FIELD CHANGE ORDER

NUMBER: DS-173Q1-F001

PROBLEM & SYMPTOM: Cross talk problem between Dispatcher cable and switched cable. Revision incompatibility problem between M7764-00 and M7763-00 module.
(See Page 2 for more detail.)

INTERCONNECTION OF MIRA MODULES (SYSTEM A is shown)

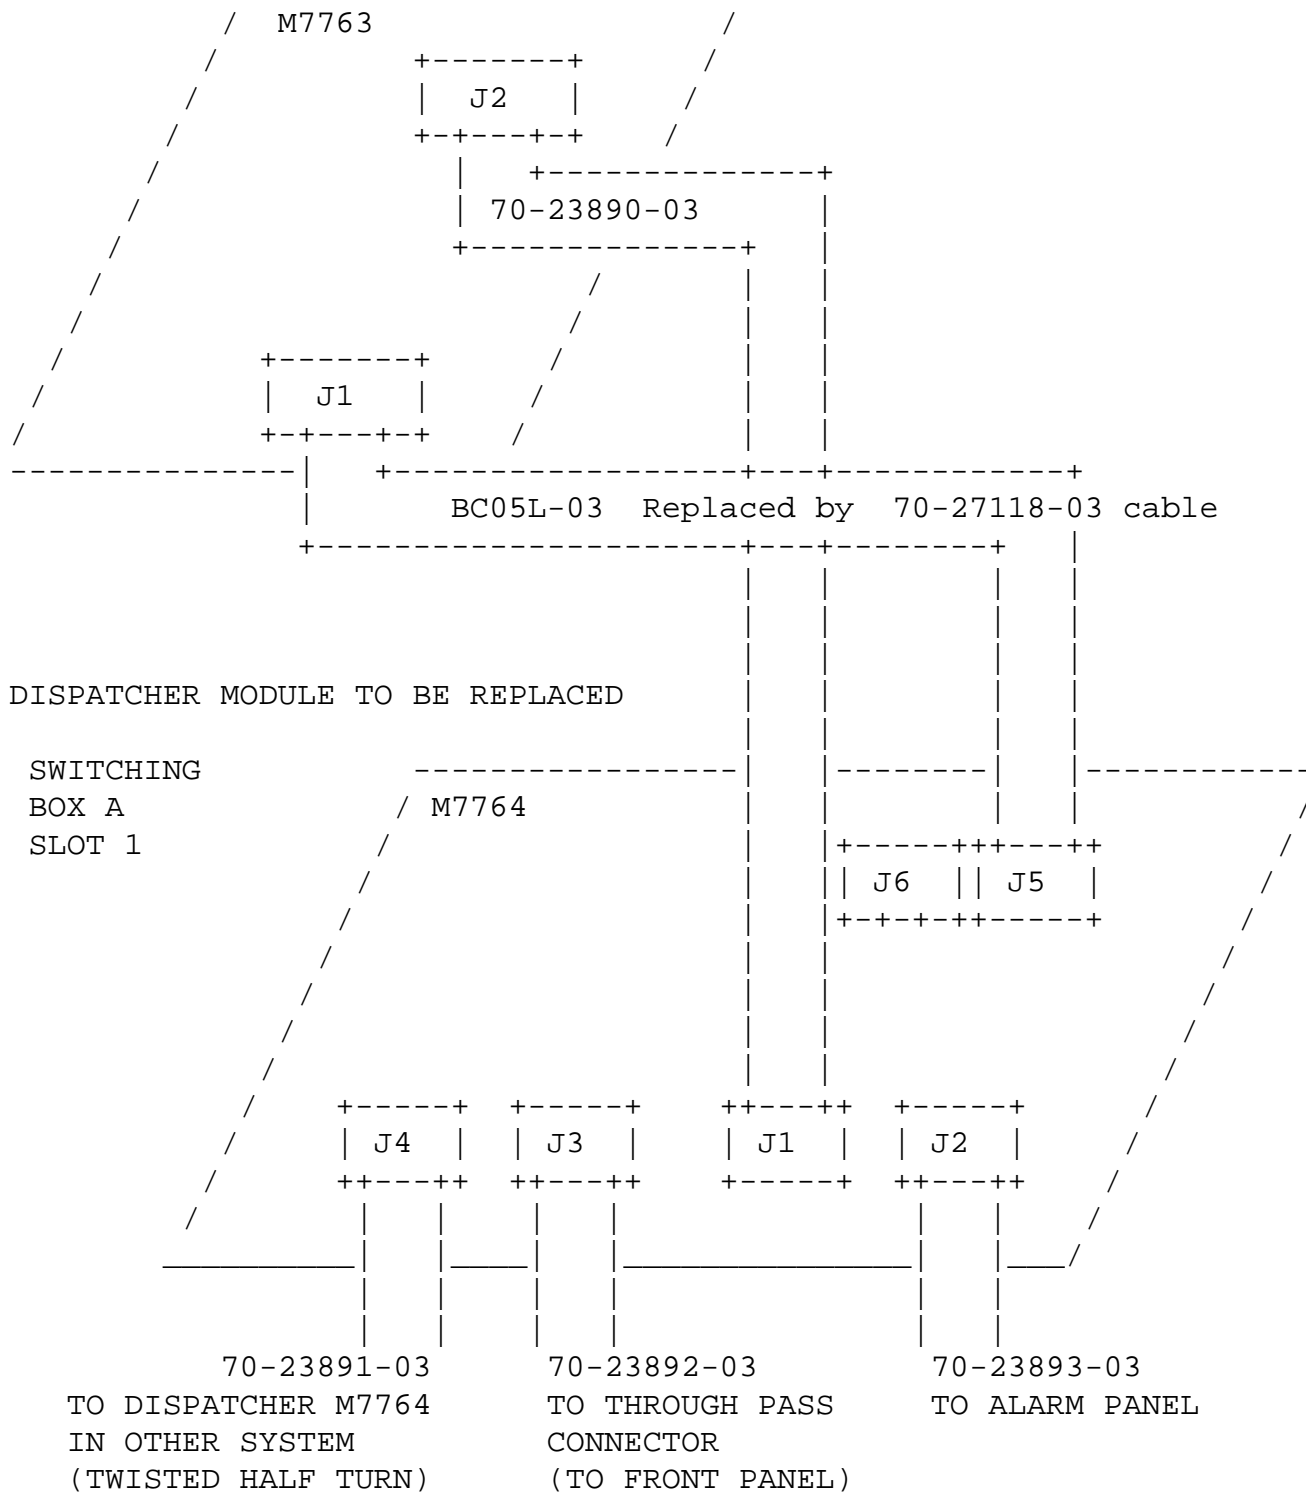
WATCH DOG MODULE TO BE REPLACED

This FCO replaces all watch-dog, dispatchers modules and BC05L cables attached to these dispatchers. This replacement requires the complete MIRA to be powered down.

Replace all modules M7763 and M7764 at Revision D or below by new modules at Rev E and replace BC05L dispatcher cables at one time.
